City of Albuquerque

**RE: BANDELIER ELEMENTARY SCHOOL - NEW MAIN ENTRANCE (L16-D28A).
Revised GRADING PLAN FOR BUILDING PERMIT APPROVAL. ENGINEER'S
STAMP DATED April 24, 2001.**

**Re: Bandelier Elementary School New Main Entrance Grading Plan
Engineer's Stamp dated 3-28-01, (L16/D28)**

**Re: Bandelier Elementary School Grading and Drainage Plan Addendum
3309 Pershing SE
Engineer's Stamp dated 12-12-07, (L16/D28)**

SECTION A-A

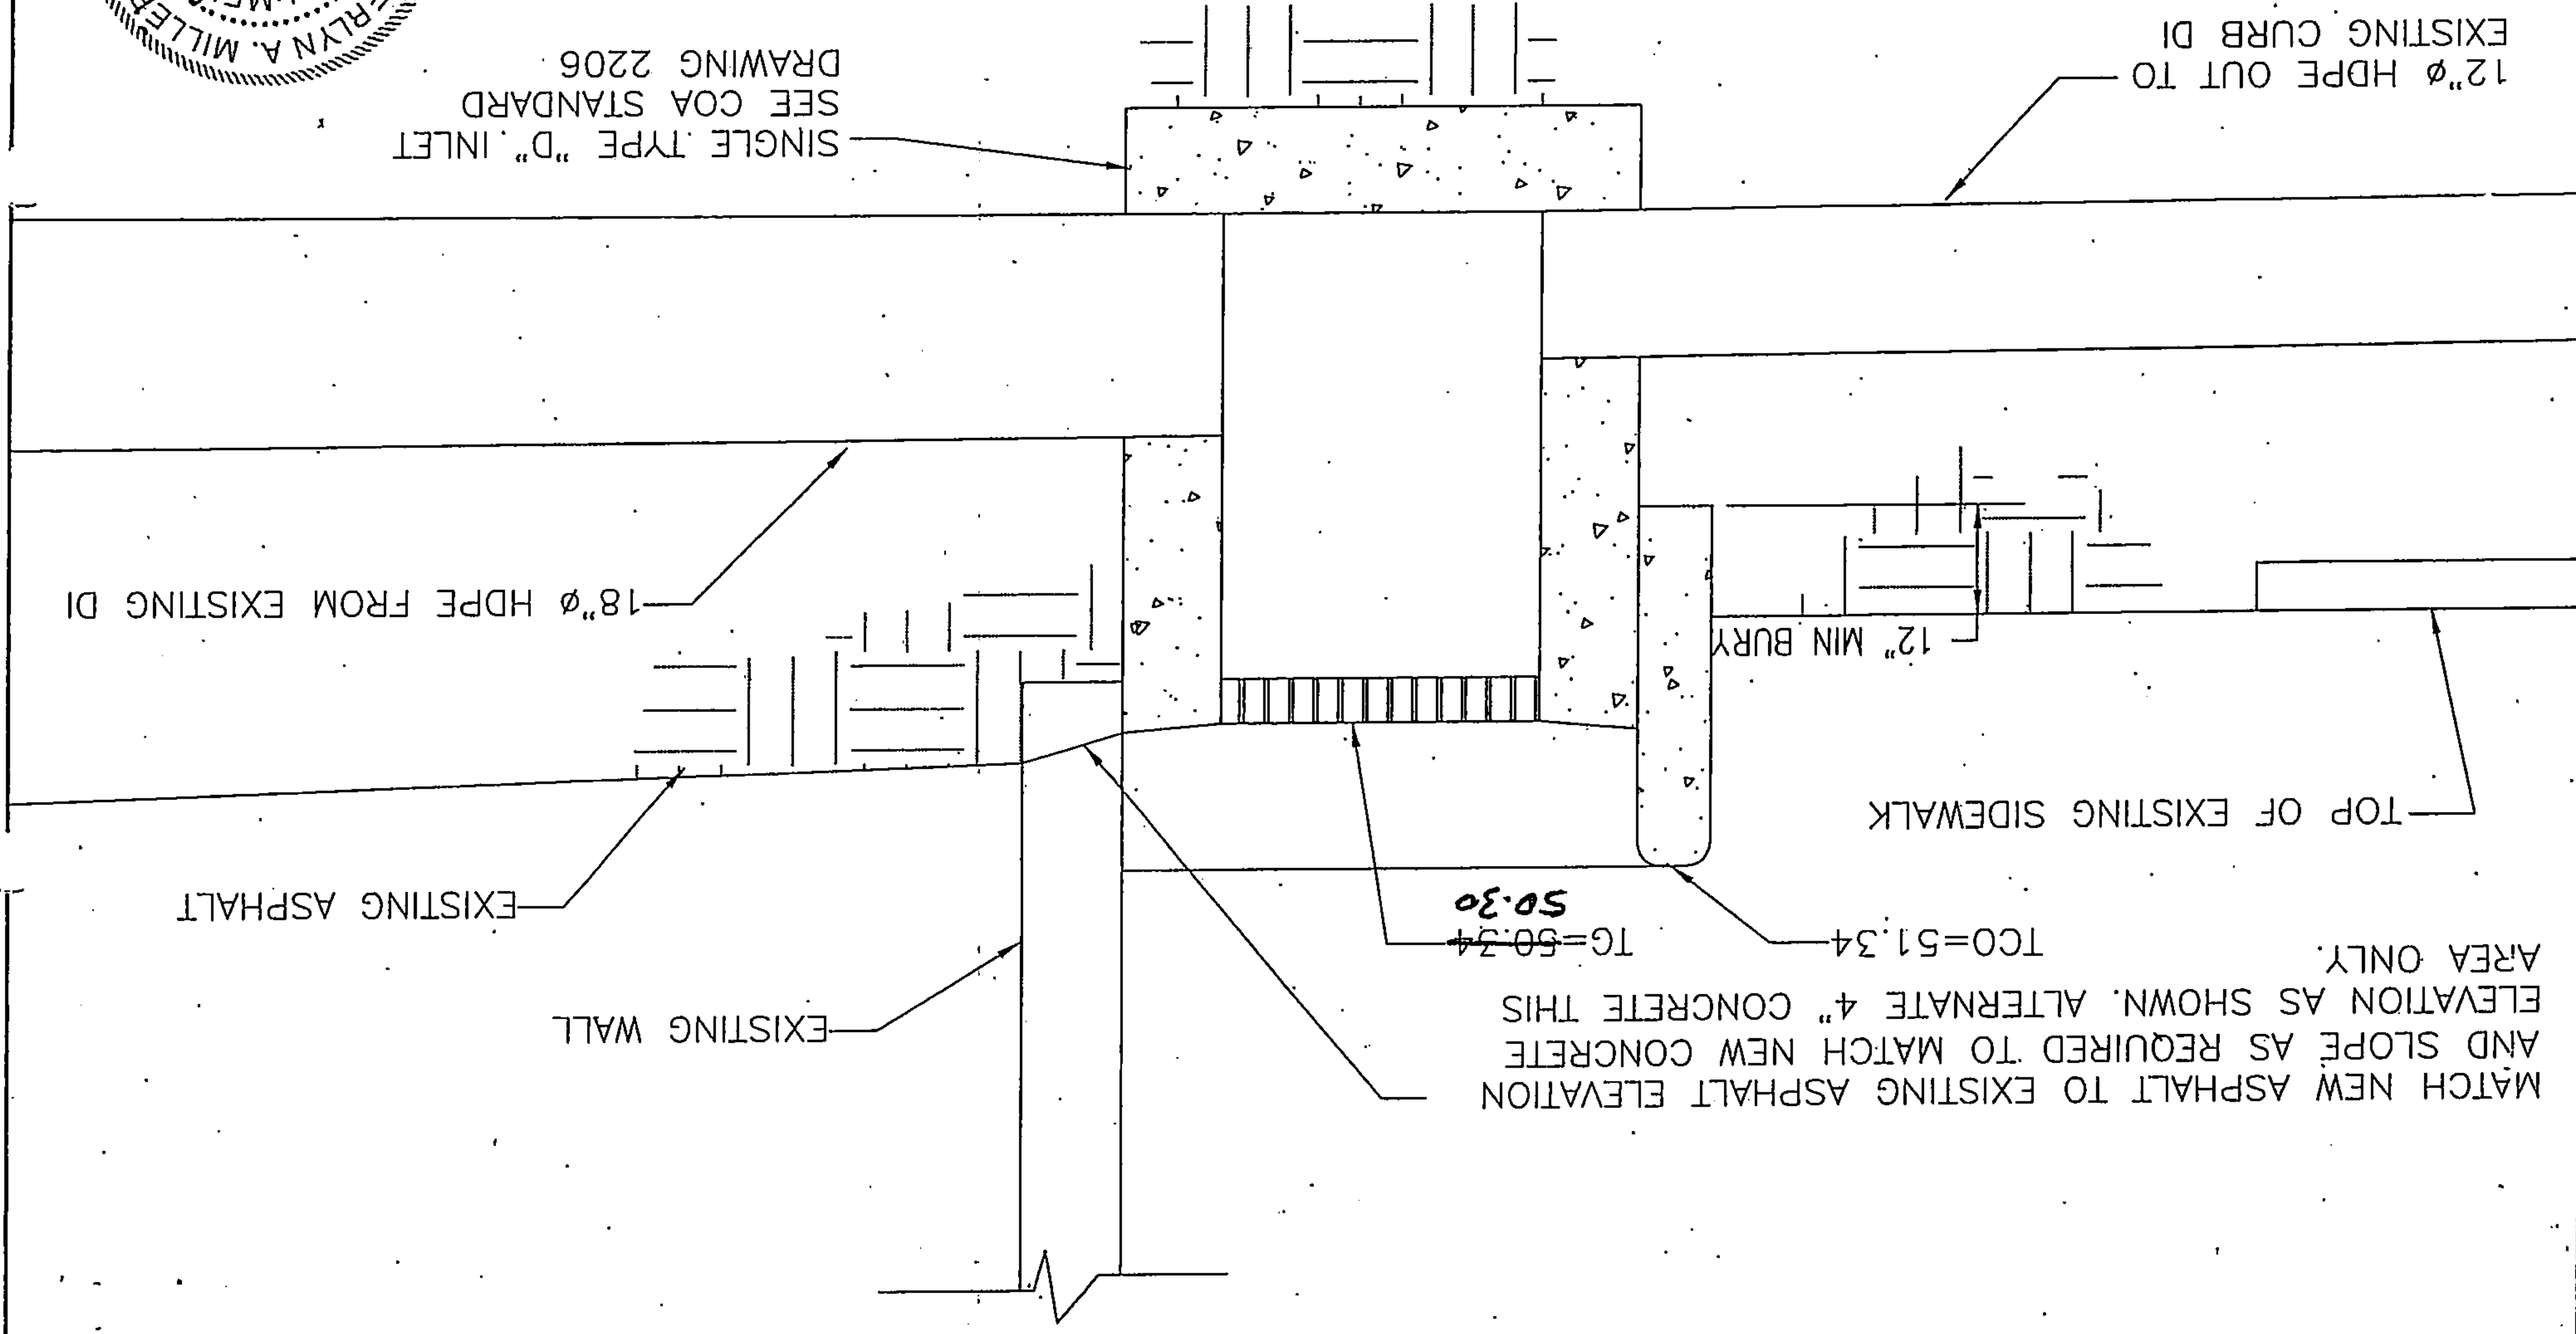
1. DELETED.
2. NEW SINGLE TYPE "D" DRAIN INLET PER COA STANDARD DRAWING #2206
TOP OF GRATE=~~50.3~~ **50.30**
INVERT (IN)=~~47.01~~ **47.08**
INVERT (OUT)=~~47.01~~ **47.08**
N: 5630.69
E: 5040.99
3. NEW 12" ϕ x 13' HDPE STORM DRAIN PIPE, S=1.5%, CONNECT TO EXISTING CURB DI IN STREET. CONTRACTOR TO FIELD VERIFY INVERT OF EXISTING CURB DI PRIOR TO CONSTRUCTION.
INVERT(IN)=~~47.01~~ **47.06**
INVERT(OUT)=~~46.81~~ **46.94**
SEE ORIGINAL STAMPED DRAWING.
4. SEE ORIGINAL STAMPED DRAWING.
5. SEE ORIGINAL STAMPED DRAWING.
6. NEW 18" ϕ x 22' HDPE STORM DRAIN PIPE, S=~~0.15%~~ **0.1%**
INVERT(IN)=~~47.11~~ **47.07**
INVERT(OUT)=~~47.01~~ **47.06**
7. DELETED.
8. SEE ORIGINAL STAMPED DRAWING.
9. EXISTING CURB DI. REMOVE ALL SILT AND DEBRIS AND FILL INVERT OF DI TO EXISTING DRAIN PIPE ELEVATION (INVERT=46.71) WITH CONCRETE, SLOPE INVERT TO DRAIN TO EXISTING DRAIN PIPE.

Based upon the information provided in your submittal received 7-11-08, the above referenced change order is approved for Building Permit & SO 19 Permit, with the condition that the pipe connection to existing City inlet must be sealed with non-shrink grout.

BANDELLER ELEMENTARY SCHOOL
CHANGE ORDER #1, SHEET C-112 R1

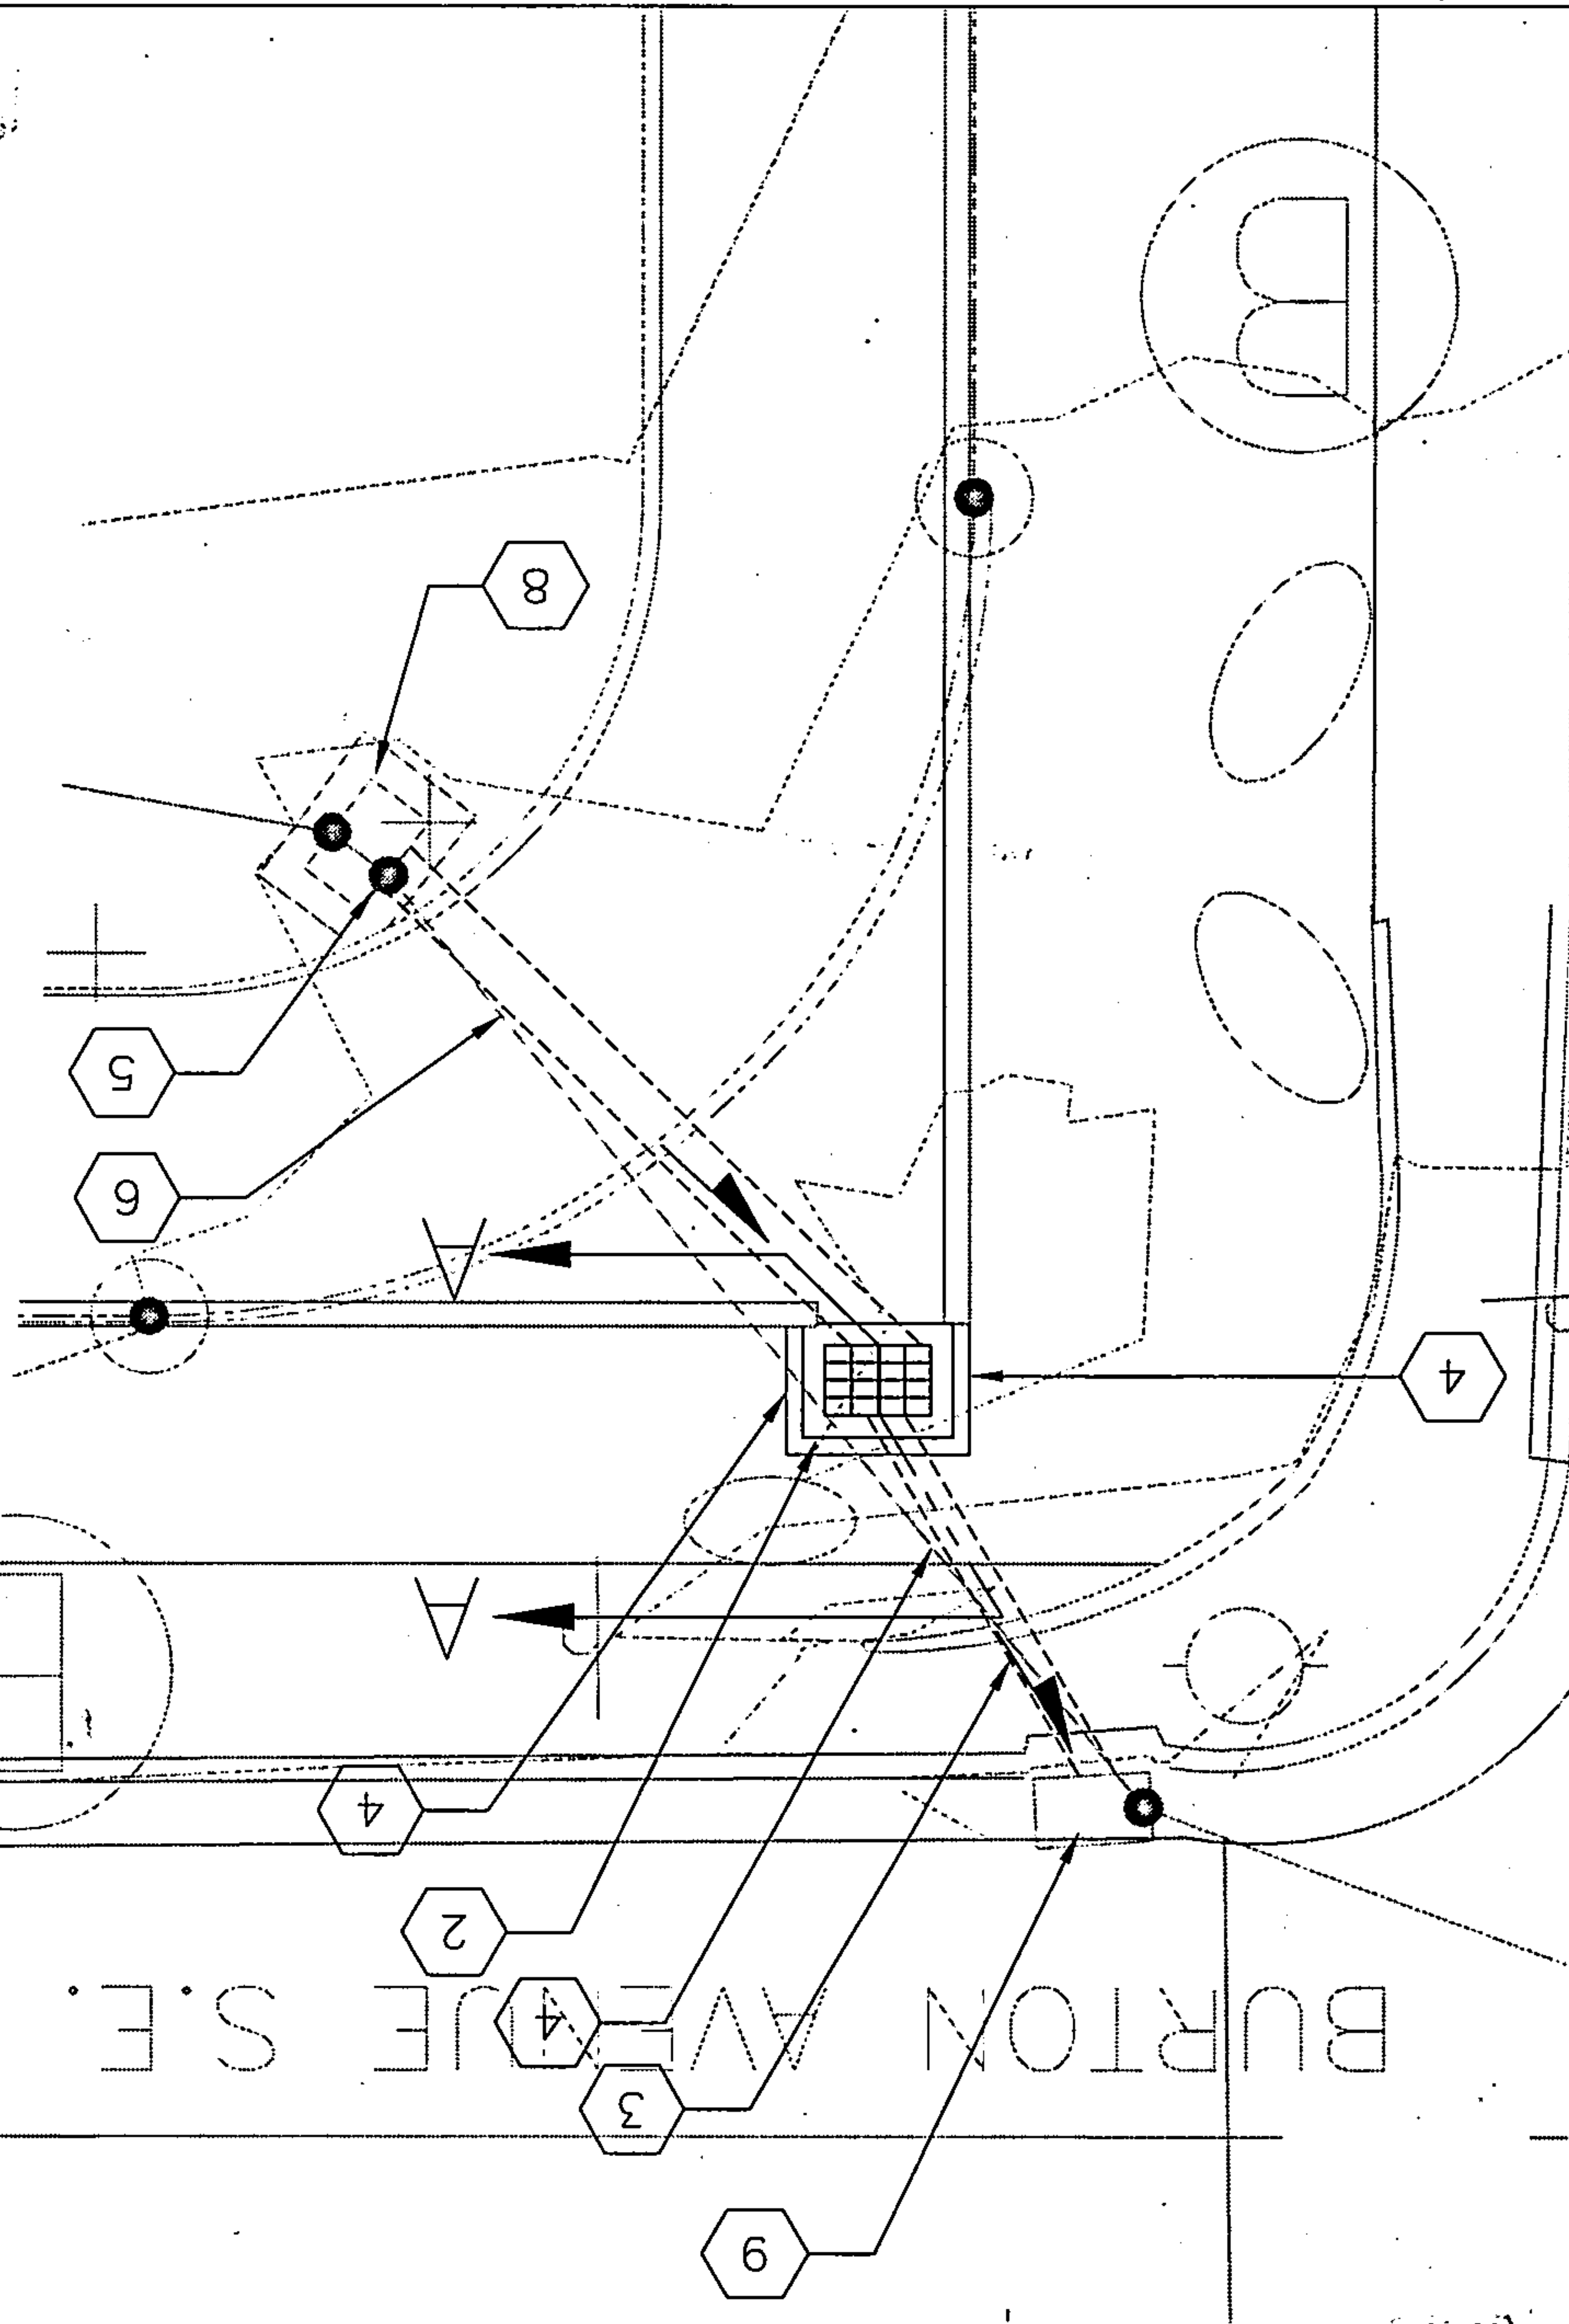
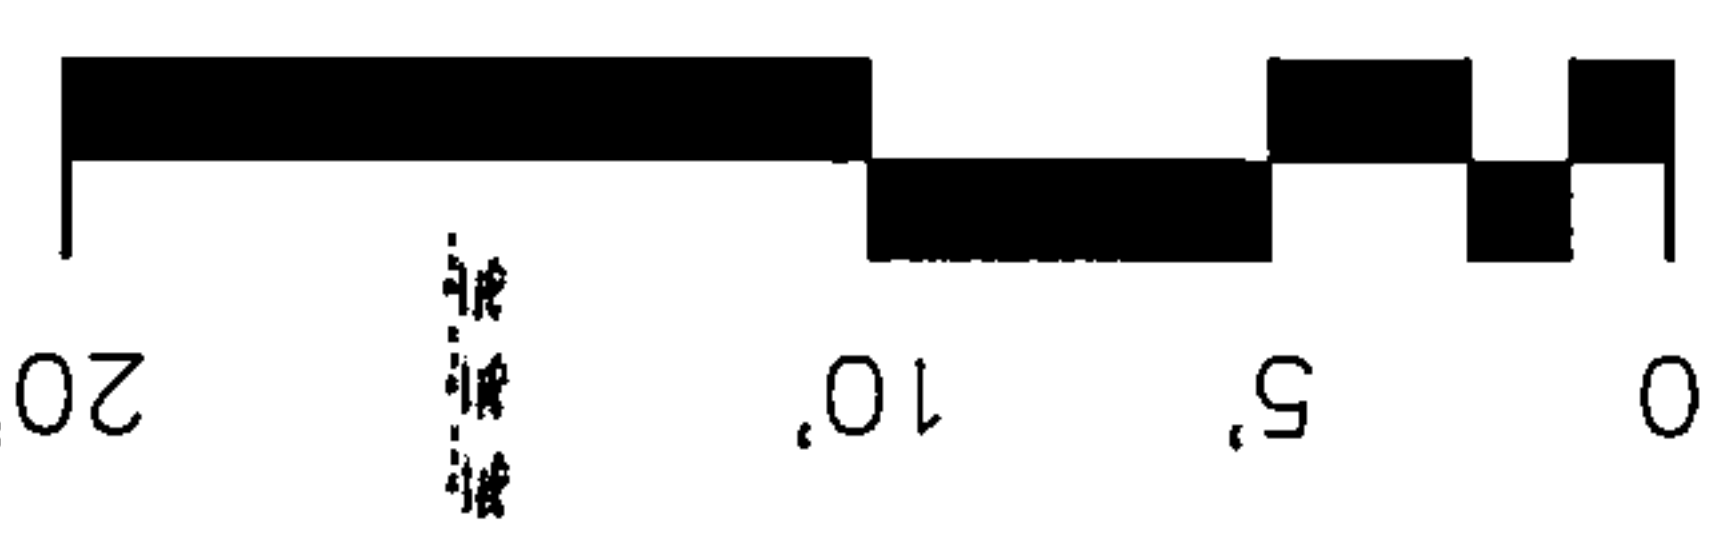
- 1. DELETED.
- 2. NEW SINGLE TYPE "D" DRAIN INLET PER COA STANDARD DRAWING #2206
TOP OF GRATE=50.34
INVERT (IN)=47.01
INVERT (OUT)=47.01
N: 5630.69
E: 5040.99
- 3. NEW 12"Ø x 13' HDPE STORM DRAIN PIPE, S=1.5%, CONNECT TO EXISTING CURB DI IN STREET. CONTRACTOR TO FIELD VERIFY INVERT OF EXISTING CURB DI PRIOR TO CONSTRUCTION.
INVERT(IN)=47.01
INVERT(OUT)=46.81
- 4. SEE ORIGINAL STAMPED DRAWING.
INVERT(IN)=47.11
INVERT(OUT)=47.01
- 5. SEE ORIGINAL STAMPED DRAWING.
- 6. NEW 18"Ø x 22' HDPE STORM DRAIN PIPE, S=0.45%
INVERT(IN)=47.11
INVERT(OUT)=47.01
- 7. DELETED.
- 8. SEE ORIGINAL STAMPED DRAWING.
- 9. EXISTING CURB DI. REMOVE ALL SILT AND DEBRIS AND FILL INVERT OF DI TO EXISTING DRAIN PIPE ELEVATION (INVERT=46.71) WITH CONCRETE, SLOPE INVERT TO DRAIN TO EXISTING DRAIN PIPE. *Seal w/ Non-Sunk Grout*
